BEFORE THE ATOMIC SAFETY AND LICENSING APPEAL BOARD

Docket No. 50-382

WATERFORD UNIT 3 BASE MAT
JOHN S. MA
STRUCTURAL AND GEOTECHNICAL ENGINEERING BRANCH
DIVISION OF ENGINEERING, NRR, NRC
DECEMBER 10, 1984

Figure 6. The Cracked Mat And Its Mathematical Model

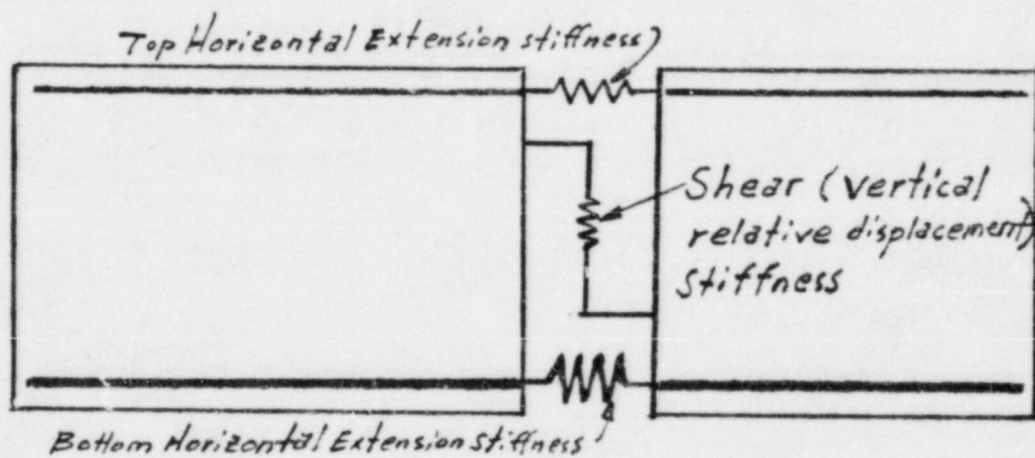
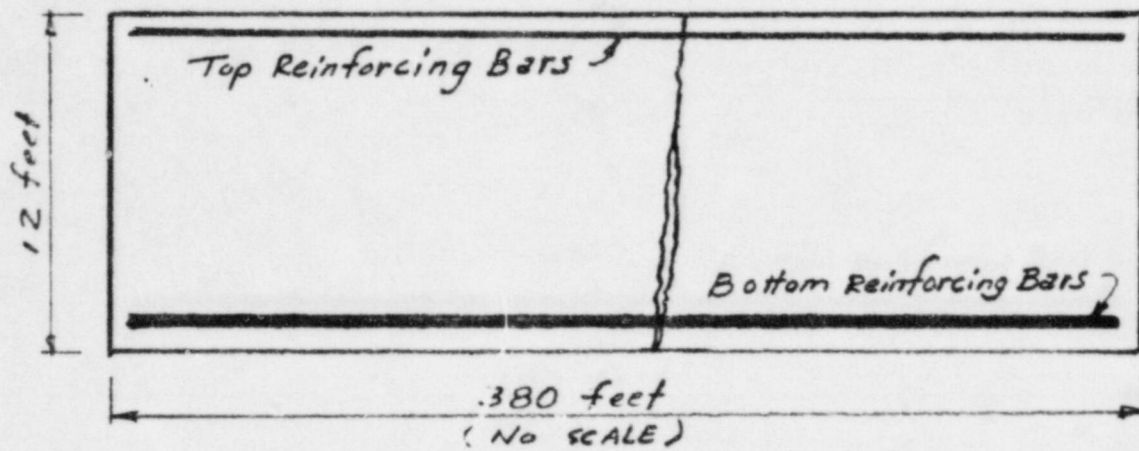
A mathematical model of the cracked mat is shown in Figure 6 without superstructures for clarity. The model represents a crack with extensive length and depth in a cross section across the width or an equivalent crack representative to the sum of all cracks within the RCB. The horizontal spring represents the top and bottom rebars, and the shear (vertical) spring represents the shear stiffness against vertical relative displacements across the crack. The behavior of the mat during

Figure 7. Cracking Bending Moment AND Its corresponding Location of Neutral Axis in the N-S Direction.

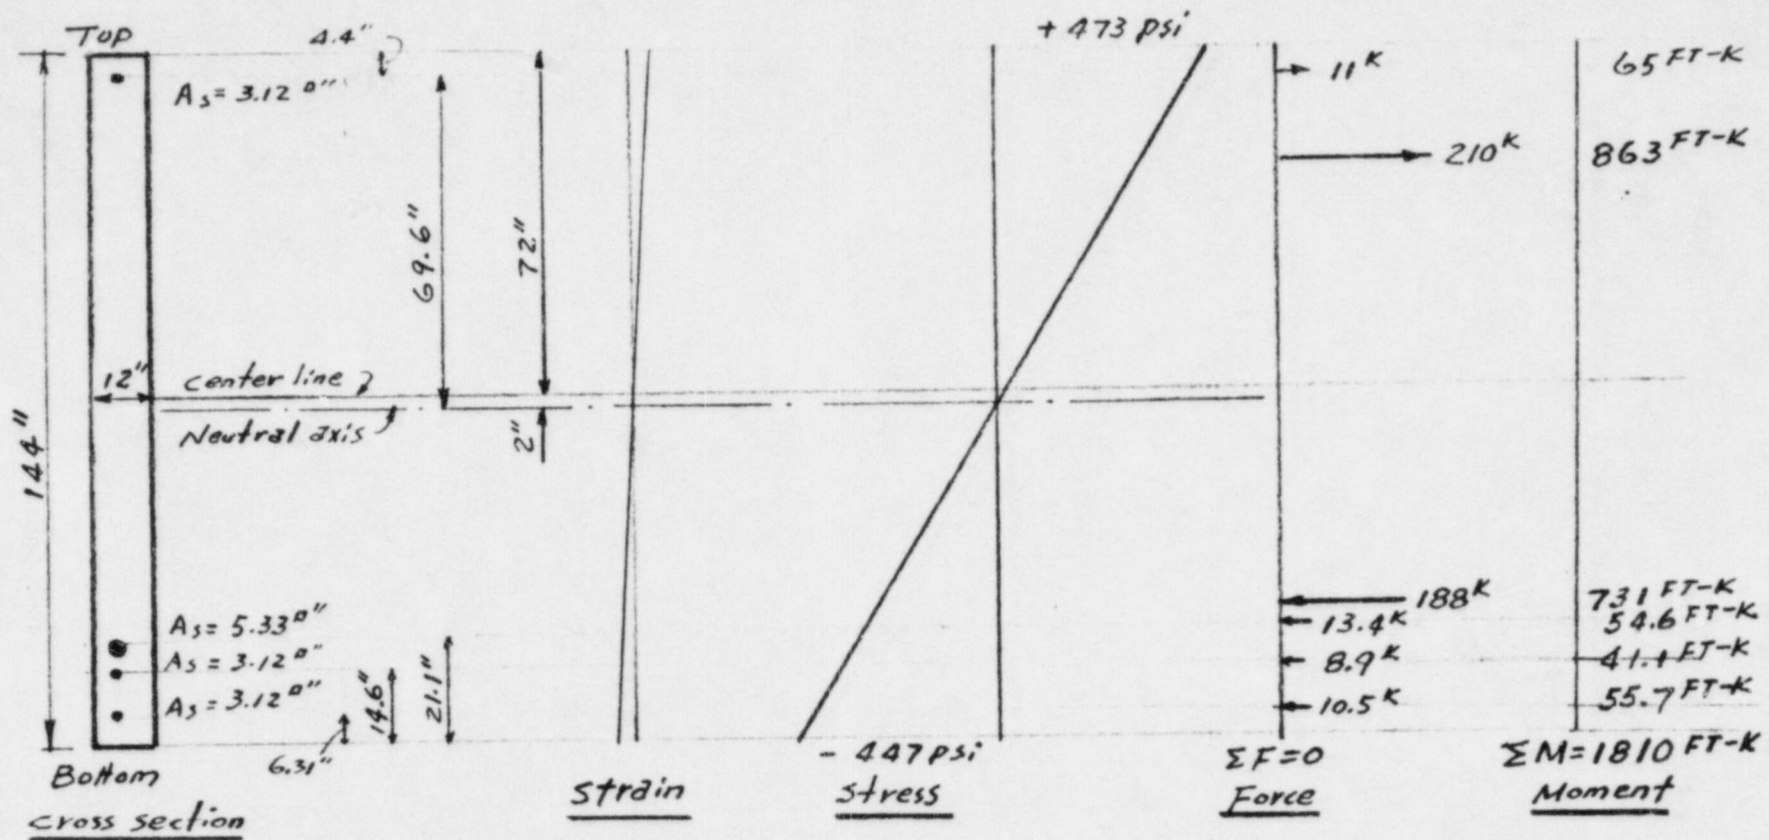
The magnitude of a bending moment required to initiate concrete cracking on the top surface of the mat and its corresponding position of the neutral axis are shown in Figure 7. The magnitude is 1810 ft-k/ft and the position of the neutral axis is 2 inches below the mid-depth. Figure 8 shows a magnitude of bending moment of 2093 ft-k/ft corresponding to a neutral axis of 18 inches above the bottom face of the mat. Where the neutral axis actually lies depends on both the magnitude of a bending moment and geometry of a cross section and properties of materials. Thus, the location of a neutral axis is neither a constant value nor independent of the bending moment acting on the cross section, unlike the BNL report implied.

Figure 8. The Bending Moment Corresponds To A Neutral Axis Located AT 18 inches Above The Bottom Face Of The Mat In The N-S Direction.

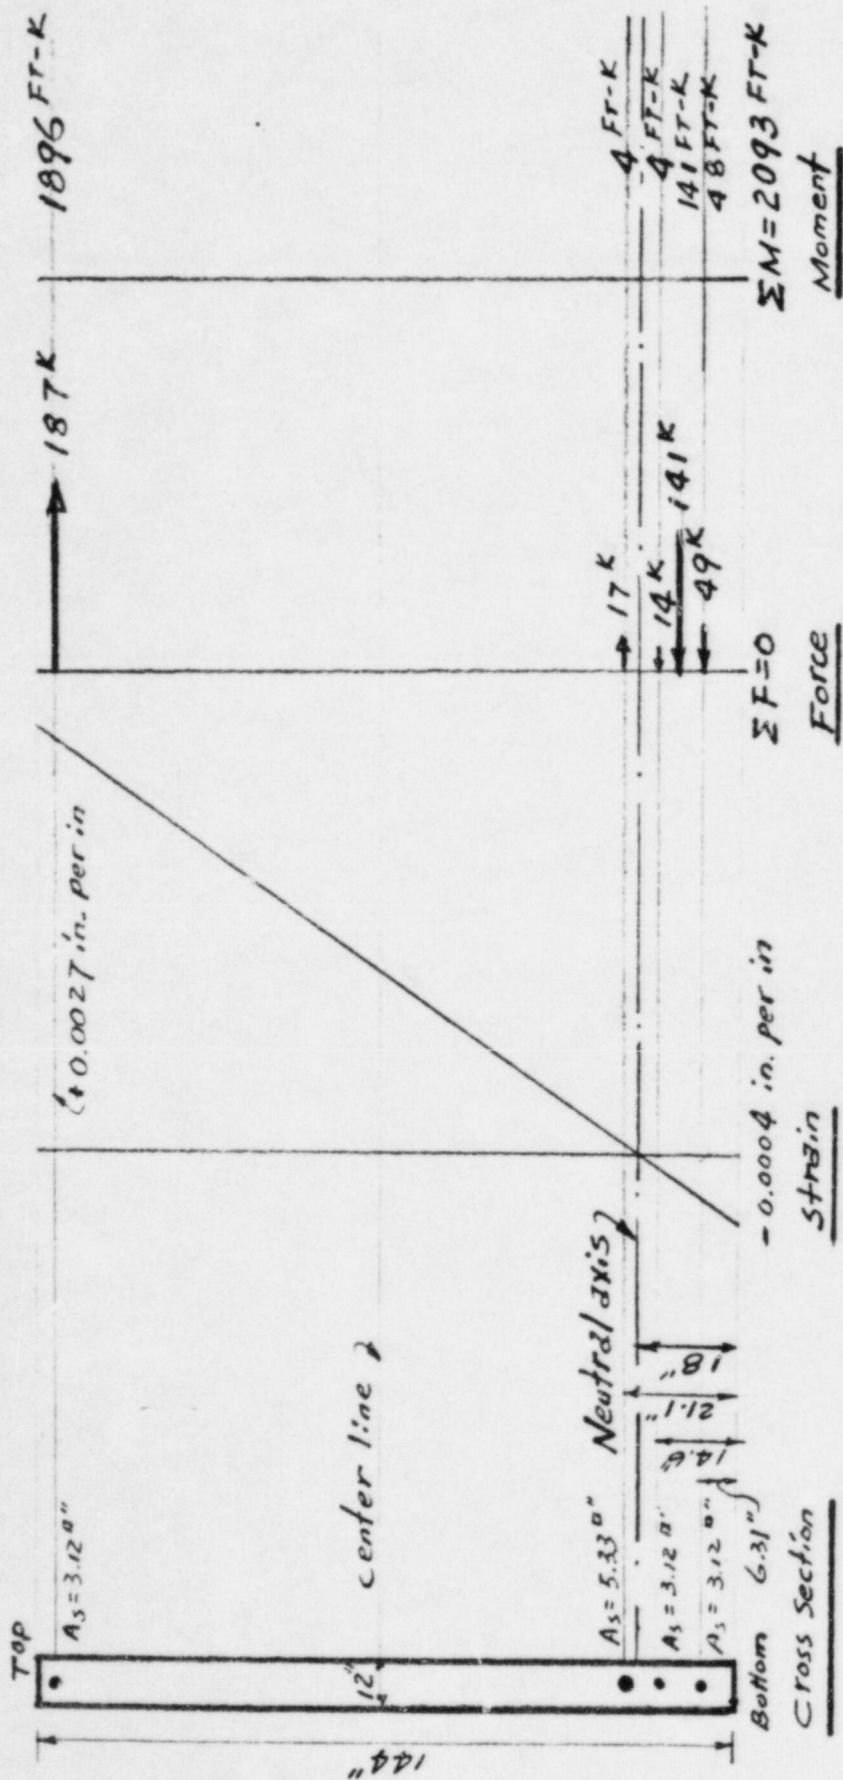
In order to push the neutral axis down to 18 inches above the bottom face of the mat as stated in the BNL addendum, it requires a magnitude of negative bending moment of 2093 ft-k/ft to act on the cross section. This magnitude is about 20 times the magnitude of a negative bending moment generated from the mat with full dead loads and no backfill soils at all with an assumed soil modulus of 150 pound per cubic inch, as shown in Fig. 2 of this report.
